Generic Design Assessment of the BWRX-300 – Step 2 Assessment - Fault Studies and Severe Accident Analysis

Report Title: Step 2 Assessment of Fault Studies and Severe Accident Analysis

Assessment report reference: AR-01348

Figure 3: Isolation Condenser System Simplified Diagram²¹

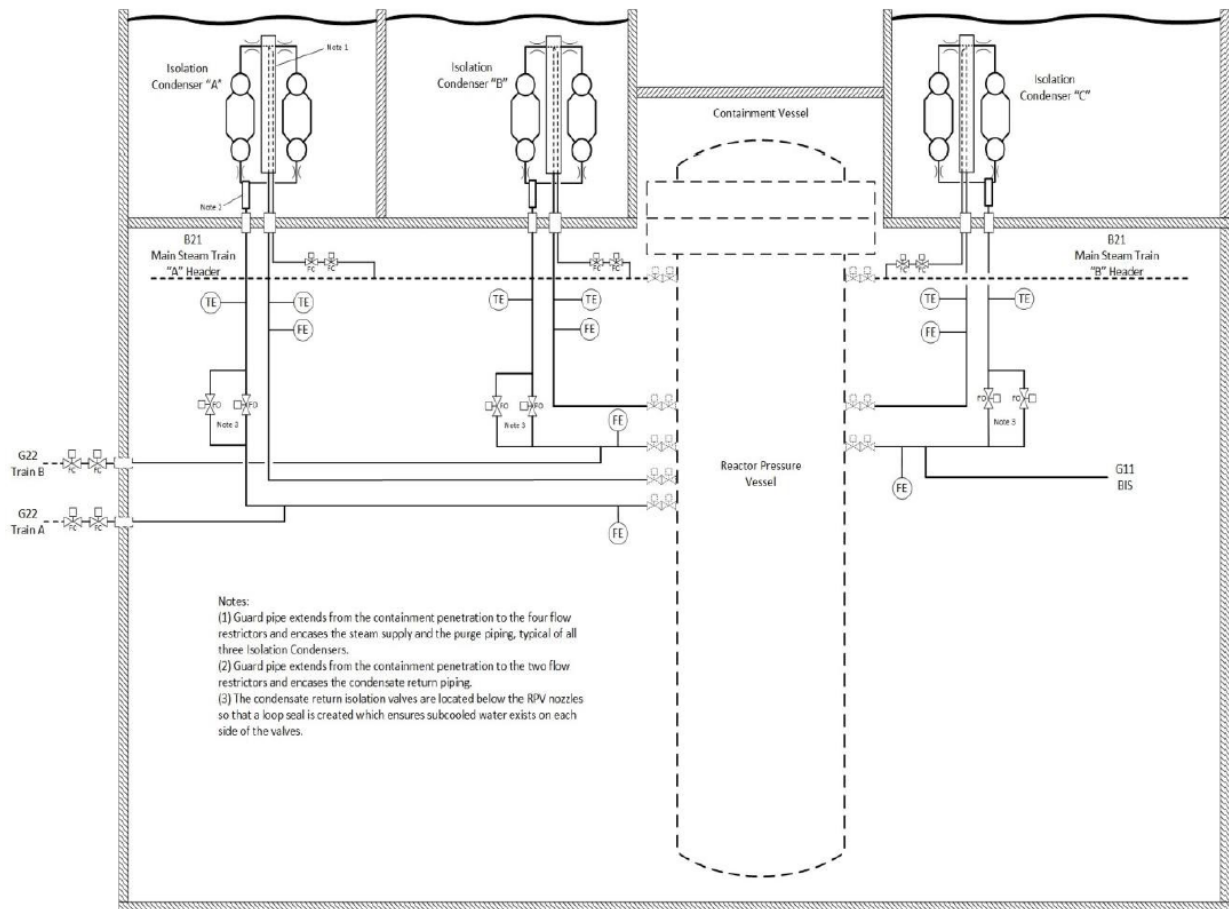
After the ICS has been deployed and the standby purge line closed, this gas is expected to build up in the lower drum of the ICS heat exchanger (see Figure 3). In response to RQ-02253 (ref. [113]), the RP has provided evidence of studies which it has now undertaken to assess the impact of radiolytic gas, the measures used to control it (catalytic recombiners) and how these measures will be demonstrated in future (by analysis and validation testing).
